Project	IEEE 802.16 Broadband Wireless Access Working Group < http://ieee802.org/16 >		
Title	Handover Optimization		
Date Submitted	2007-11-04		
Source(s)	Shashikant Maheshwari, Yousuf Saifullah, Haihong Zheng, Giovanni Maggi, Aik Chindapol Nokia Siemens Networks	Voice: E-mail:	shashikant.maheshwari@nsn.com * http://standards.ieee.org/faqs/affiliationFAQ.html >
Re:	In response to LB26		
Abstract	This contribution proposed bandwidth efficient HO optimization procedure to reduce HO interruption time.		
Purpose	Accept the proposed specification changes on IEEE P802.16Rev2/D1.		
Notice	<i>This document does not represent the agreed views of the IEEE 802.16 Working Group or any of its subgroups. It represents only the views of the participants listed in the "Source(s)" field above. It is offered as a basis for discussion. It is not binding on the contributor(s), who reserve(s) the right to add, amend or withdraw material contained herein.</i>

Handover Optimization

*Shashikant Maheshwari, Yousuf Saifullah, Haihong Zheng, Giovanni Maggi, Aik Chindapol
Nokia Siemens Networks*

Figure 1: Fully optimized Handover procedure

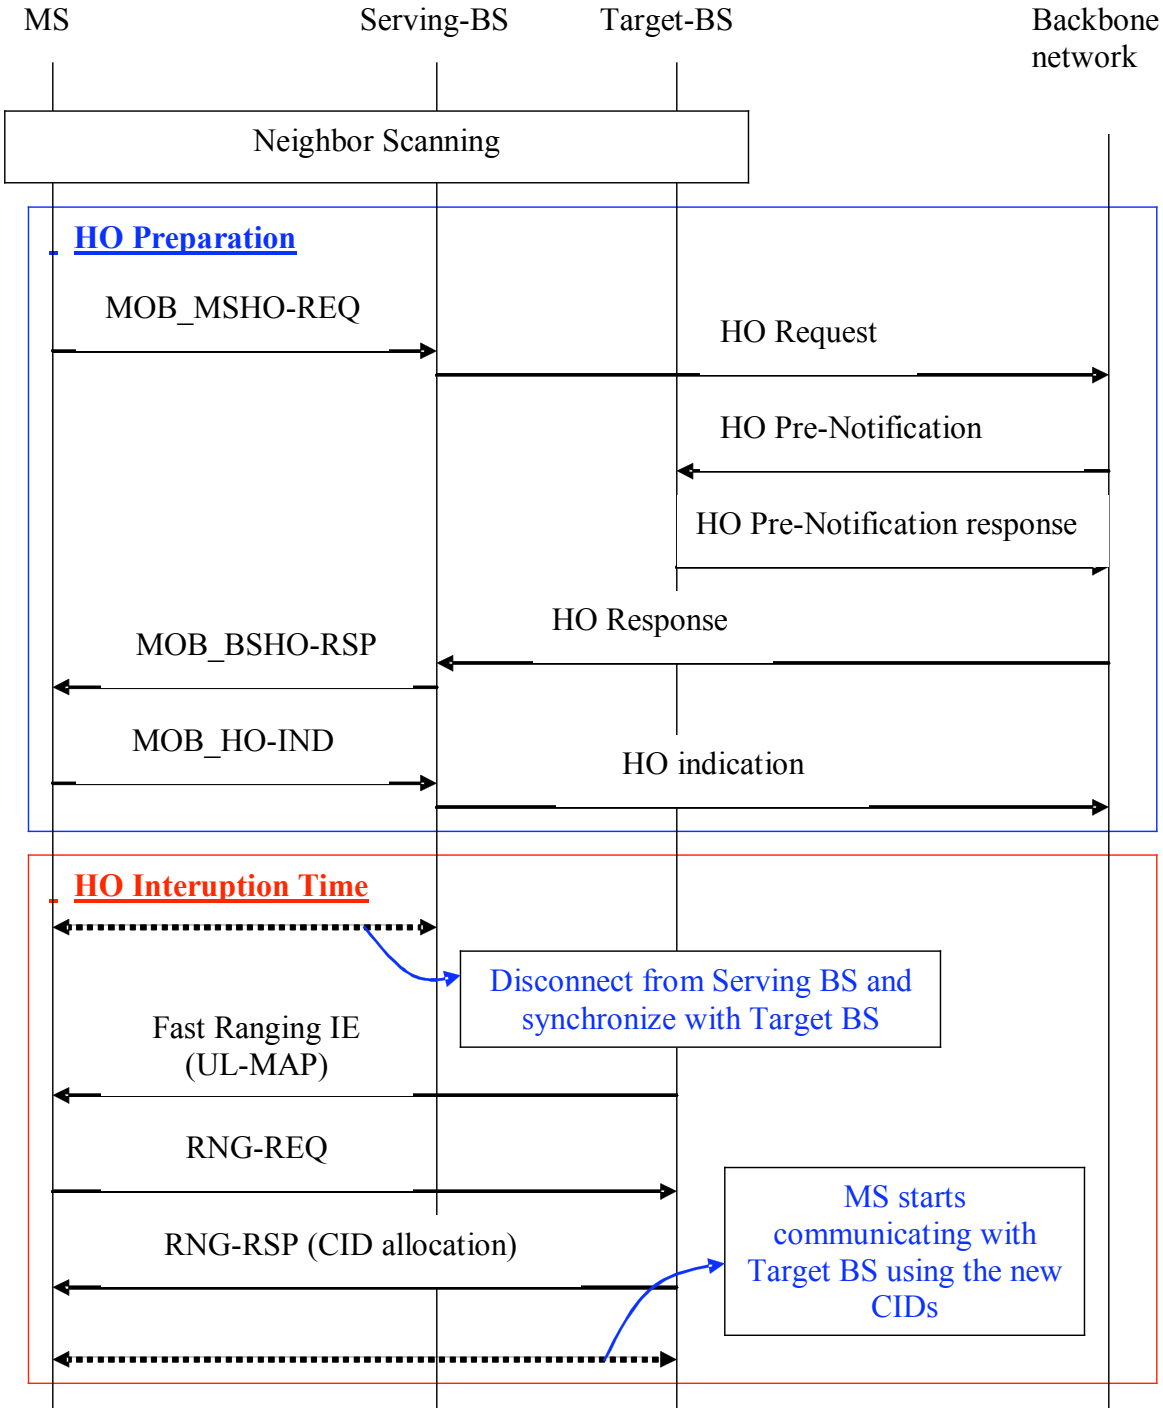
TargetBS and MS is still required to exchange RNG-REQ and RNG-RSP messages to complete the MS network entry and allocate new CIDs. Therefore, HO interruption time still could be higher. Figure 1 shows the full-optimized HO procedure as defined in IEEE 802.16e-2005.

Figure 2: proposed Handover enhancement for Latency and overhead reduction

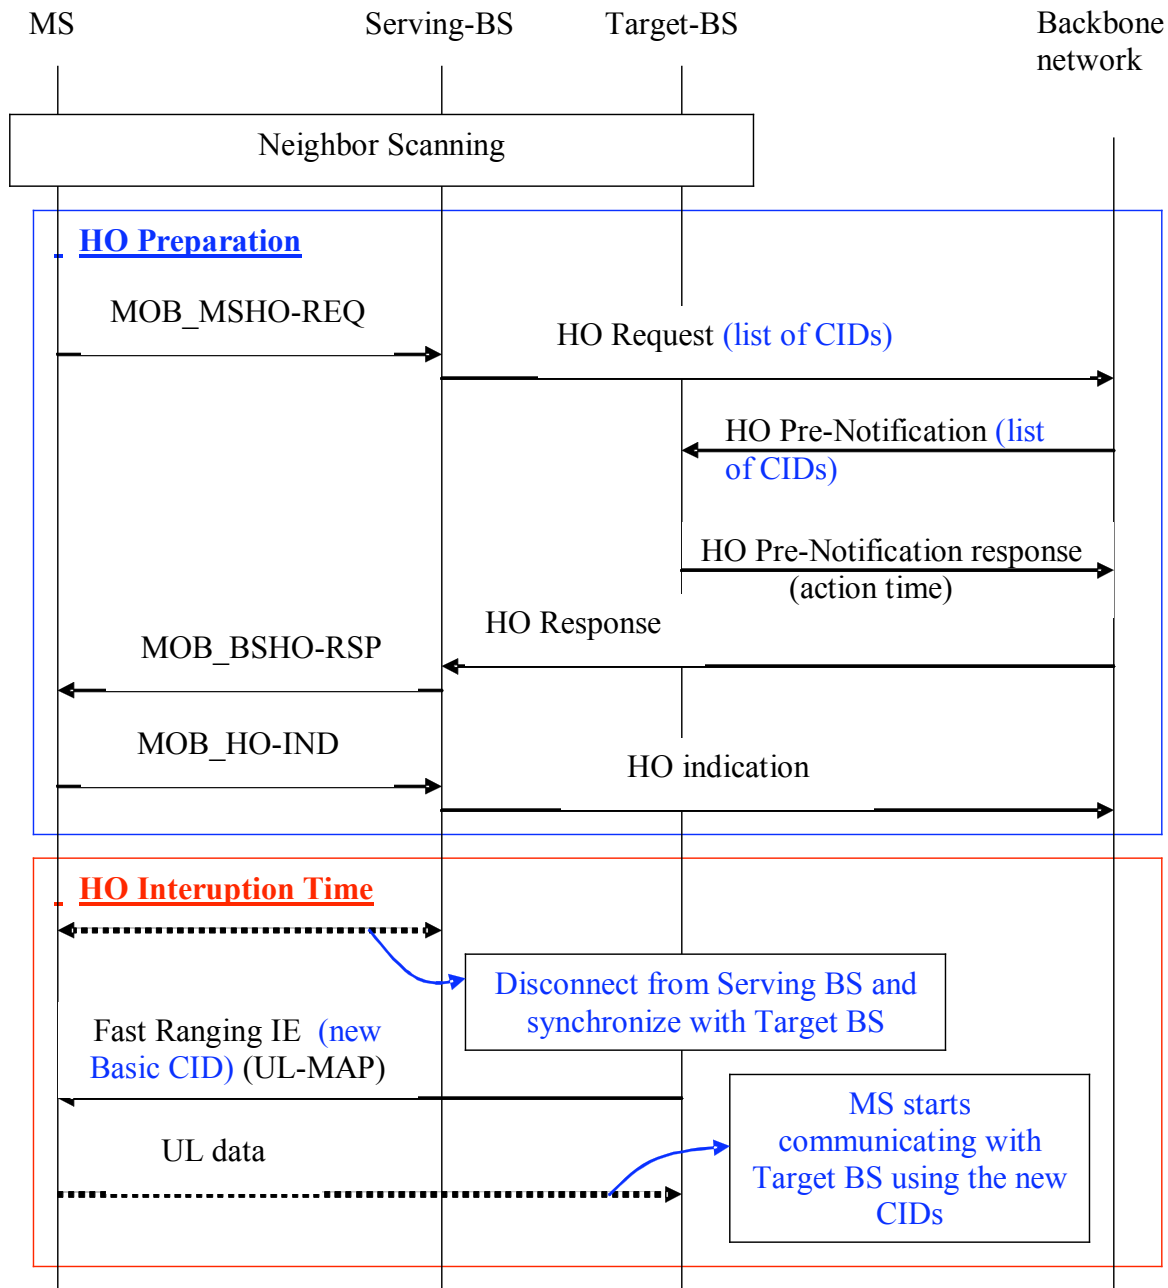
This contribution proposes to remove the exchange of RNG-REQ and RNG-RSP messages during the network re-entry when HO is fully optimized and action time and fast_ranging_IE are used. We propose performing

CID update for Basic CID through fast_ranging_IE and implicit CID mapping for remaining CIDs i.e primary, secondary and transport CIDs. Figure 2 described the message flow for the proposed scheme.

- BS allocates contiguous range of CIDs to MS.
 - 16 bits CID is split into 12 bit and 4 bit region. That will give 16 CIDs for MS. First, second and third CIDs represents Basic, primary and secondary CIDs and remaining CIDs are transport CIDs. BS allocate transport CID from the MS CID range. Basic CID consists of 12 bits + 4 bits

- (which is all zeros).
- Basic CID allocation during Handover procedure
 - For a faster handover, Fast Ranging IE is sent anyway from the BS
 - Serving BS transfers the old CIDs along with the MS service flow context to Target BS.

- Modify Fast Ranging IE to include 12 bit Basic CID assigned by the target BS.
 - Use reserved bits in the Fast Ranging IE to indicate the presence of the new CIDs for REV2 capable MS

Figure 3: Implicit CID mapping

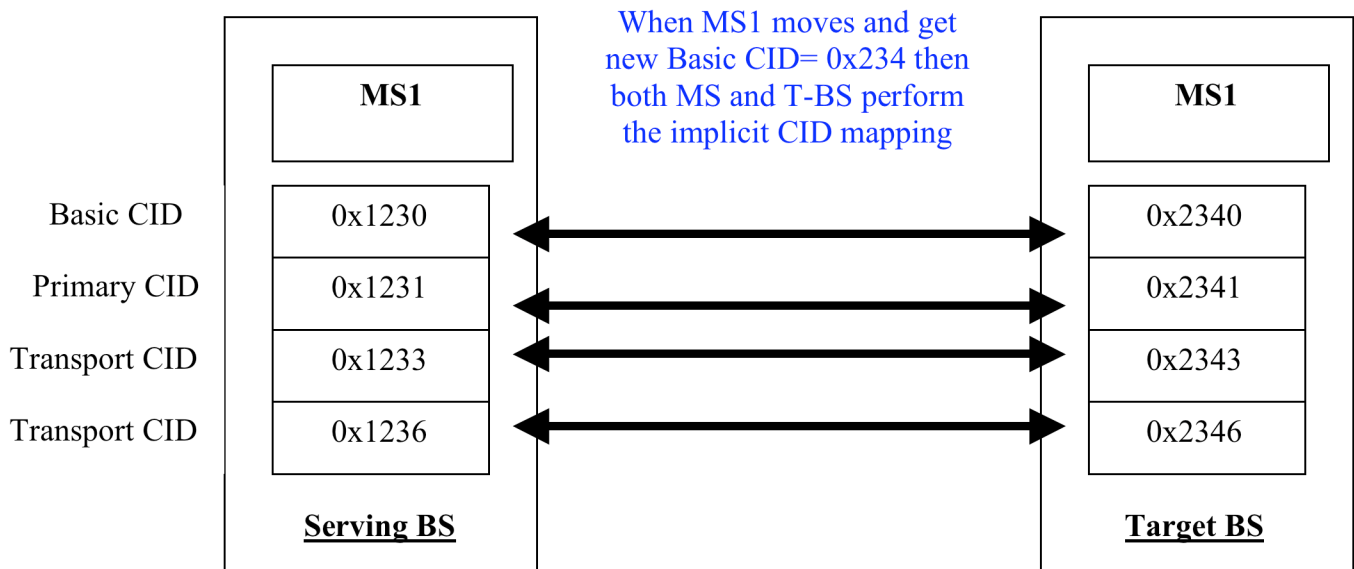
- Implicit CID mapping
 - When MS receives the new Basic CID, it maps the other CIDs according to the offset it has with old Basic CID. Please see figure 3 for example.

If BS assigns Basic CID = 0x1230 to MS1. (last 4 bits of Basic CID should be 0). Then CID range for MS1 is from 0x1230 – 0x123F
 If BS assigns Basic CID = 0x1240 to MS2. (last 4 bits of Basic CID should be 0). Then CID range for MS2 is from 0x1240 – 0x123F

If MS requires addition CIDs then BS may allocate another range of CID having last 4 bits are set to 0.
